Subject: Virgil C. Summer Nuclear Station (VCSNS) Units 2 and 3 Combined License Application (COLA) - Docket Numbers 52-027 and 52-028 Response to NRC Request for Additional Information (RAI) Letter No. 056

Reference: Letter from Chandu P. Patel (NRC) to Alfred M. Paglia (SCE&G), Request for Additional Information Letter No. 056 Related to SRP Section 2.5.4 for the Virgil C. Summer Nuclear Station Units 2 and 3 Combined License Application, dated July 9, 2009.

**NRC RAI Letter No. 056 Dated July 9, 2009**

**SRP Section: 2.5.4 – Stability of Subsurface Materials and Foundations**

Figure 2.5.4-219: Profile Location Map Showing Excavation Geometry, Unit 2  
 (Sheet 1 of 2)

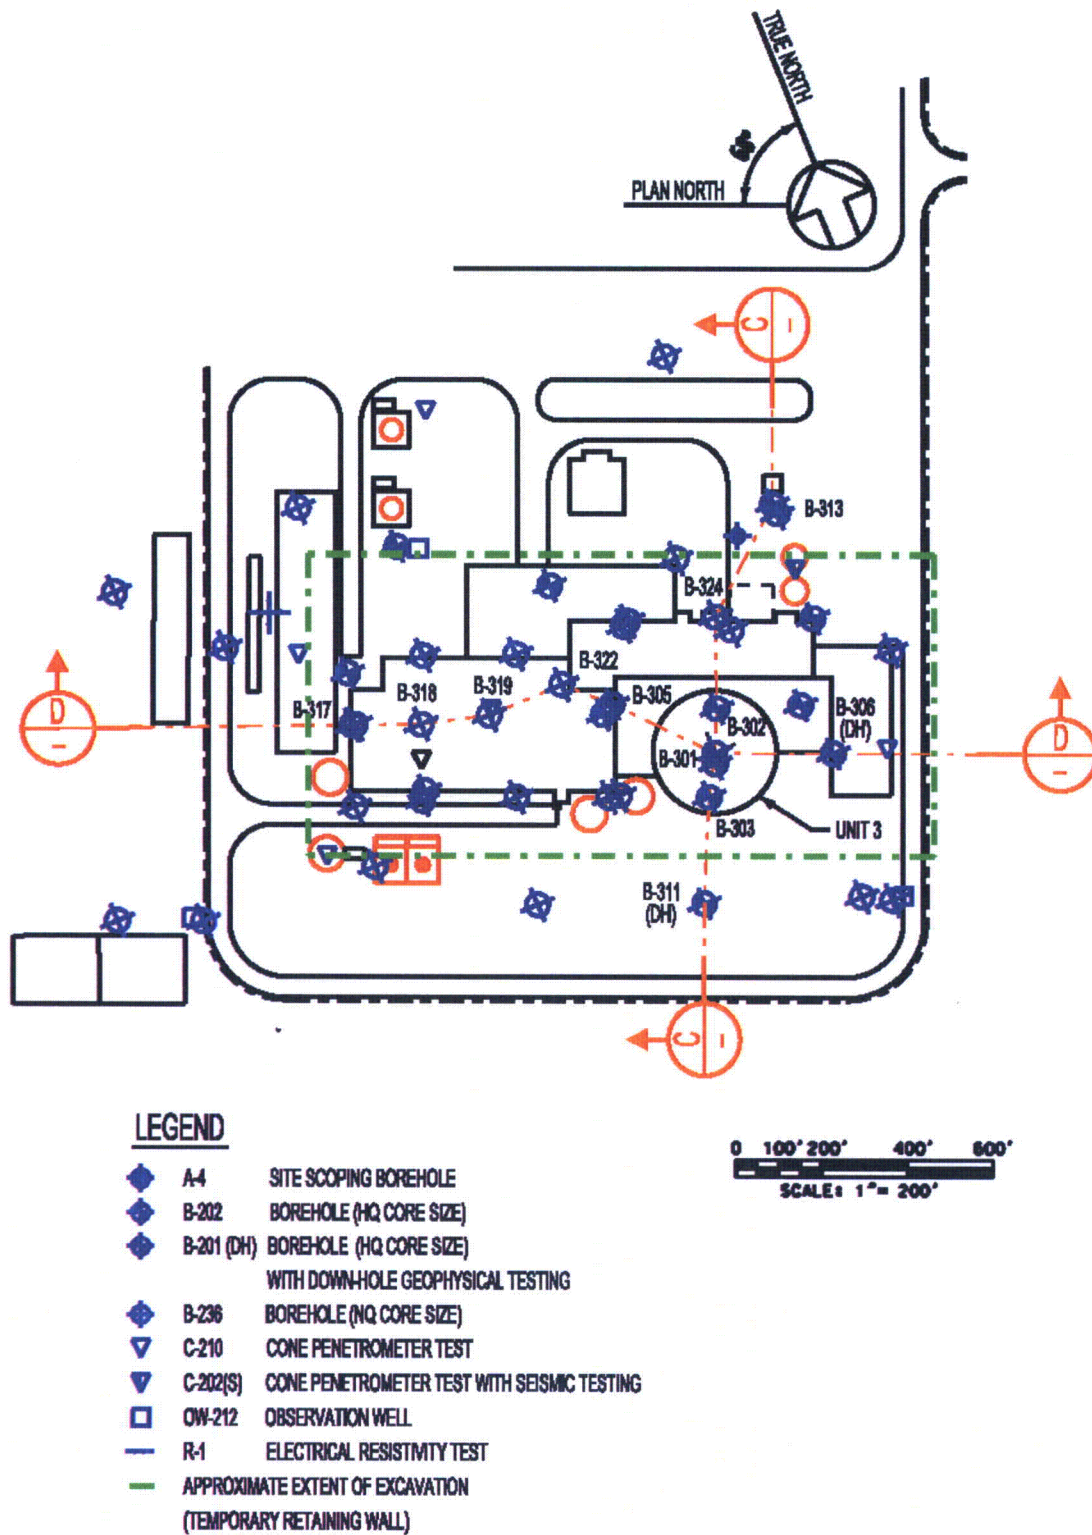
In response to RAI 02.05.04-8, you stated that more detailed excavation and backfill plans are currently being developed, and you concluded that common fill at the site, based on the detailed plans, will not have adverse impact on the foundation stability. In order for us to better evaluate the foundation stability, please provide updated excavation and backfill plans.

Revised FSAR Figure 2.5.4-219 (Sheets 1 & 2) show the general extent of the planned excavations for the Unit 2 and 3 power blocks and the location of profiles through the excavated and backfilled areas. The outline of the approximate extent of excavation shown in each figure is that of the temporary H-pile (soldier pile and lagging) retaining walls which will provide adequate clearance for construction of the power block structures and components.

Revise FSAR Figures 2.5.4-219 through 2.5.4-223 as shown below:
